TVA-BFN-TS-421

BROWNS FERRY NUCLEAR PLANT (BFN) - UNITS 1, 2, AND 3 - TECHNICAL SPECIFICATIONS (TS) CHANGE 421 - FRAMATOME FUEL DESIGN AND STORAGE

Technical Specifications (TS) Change 421 Framatome Fuel Design And Storage

Proposed Technical Specifications Changes (mark-up)

4.2.1 Fuel Assemblies

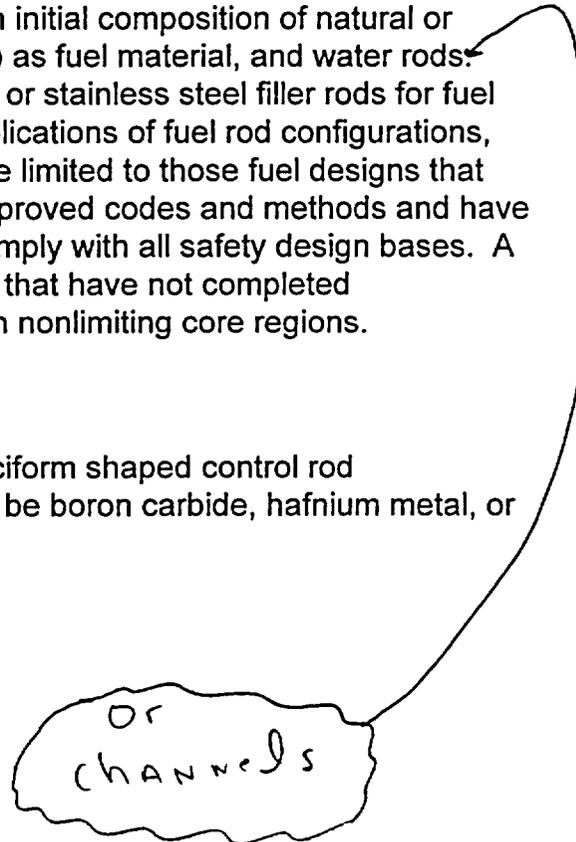
The reactor shall contain 764 fuel assemblies. Each assembly shall consist of a matrix of Zircalloy fuel rods with an initial composition of natural or slightly enriched uranium dioxide (UO_2) as fuel material, and water rods. Limited substitutions of zirconium alloy or stainless steel filler rods for fuel rods, in accordance with approved applications of fuel rod configurations, may be used. Fuel assemblies shall be limited to those fuel designs that have been analyzed with NRC staff approved codes and methods and have been shown by tests or analyses to comply with all safety design bases. A limited number of lead test assemblies that have not completed representative testing may be placed in nonlimiting core regions.

OR
CHANNELS
